Amendments to the Drawings:

Attachments: Replacement Sheets (2)
Annotated Sheets (2) Showing Changes

FIG. 1

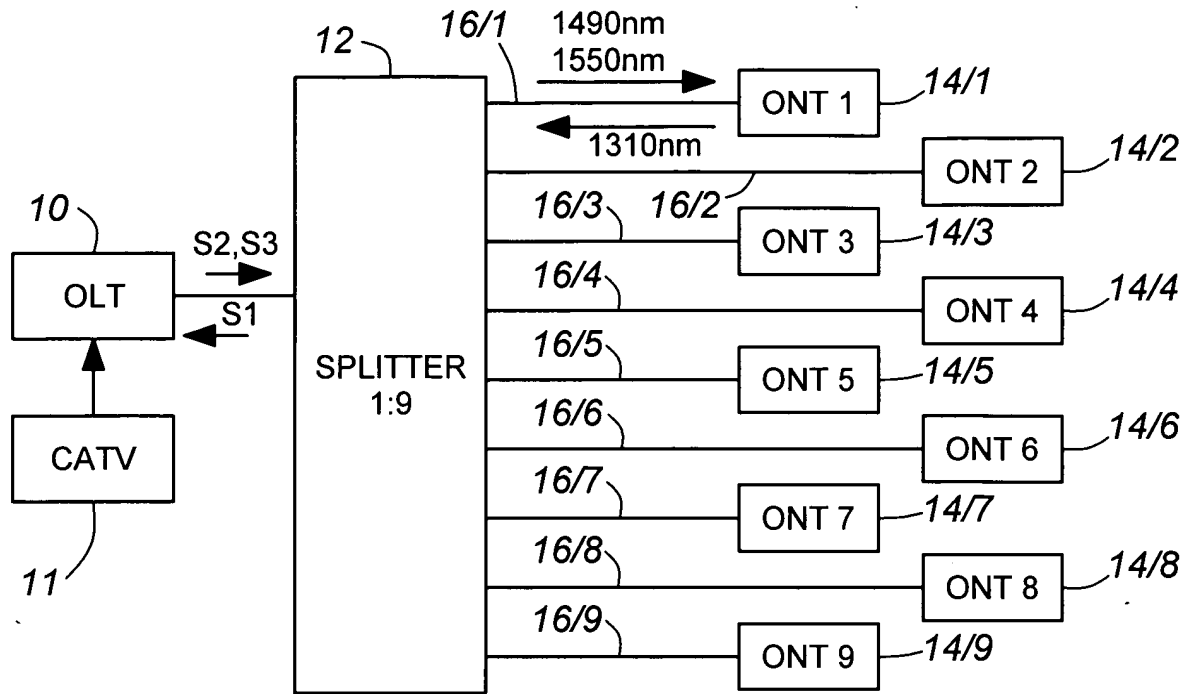
The replacement sheets of drawings, which include Figures 1, 2 and 3, replace the original sheet which included Figures 1, 2 and 3. In amended Figures 1 and 2, a CATV source 11 has been added and, in all Figures, symbols S1, S2, S3; S1', S2', S3'; S1'', S2'', S3''; and S2''', S3''' included to designate the optical signals and portions or parts thereof. In Figure 2, a legend has been added to link the symbols with the corresponding wavelengths. Also, the depiction of the splitter 40 has been corrected, and the captions in boxes 38, 42, 44, 54, 56 and 58 have been changed.
